**KENWAY
CORPORATION**

Brookfield BRFLBR (2)

Nonconformance

Figure 1 – Vertical Wall, Bay 1

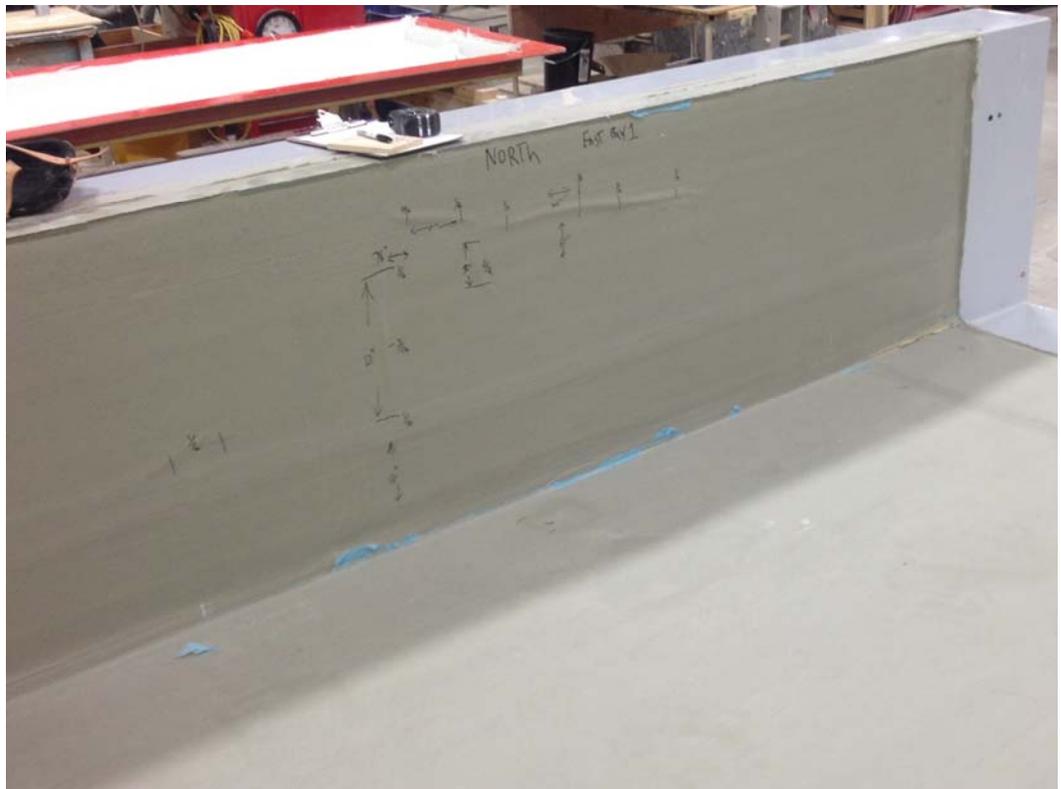
After de-molding the hull for Pontoon 3 (PN 3-1), Kenway noticed several wrinkles on the part. The mold surface has resin rich lines and the bag side of the part displays wrinkles that protrude less than 3/16 in. above the surface (less than 1/8 in. beyond specification) and less than 3/4 in. wide. The wrinkles do not conform to: ASTM D2563, Table 1, Allowable Defects – Level II, which requires wrinkle height to be less than 10% of laminate thickness – in this case less than 1/16 in.

Kenway recommends performing the following steps, which have been approved to repair wrinkles in PN 2-9a (NCR 5), to repair the 5 nonconforming areas where wrinkle height is equal to or greater than 1/8 in. and wrinkle length is equal to or greater than 12 in.

1. Grind down the proud areas on the bag surface to satisfy flatness requirements.
2. Grind out the resin rich areas on the mold surface at a 12:1 taper.
3. Replace ground out material with glass specified for the project with each ply tapered to fit the cavity.
4. Vacuum infuse the area with resin specified for the project and allow to cure.
5. Remove infusion consumables from the area and inspect for proper wet out.
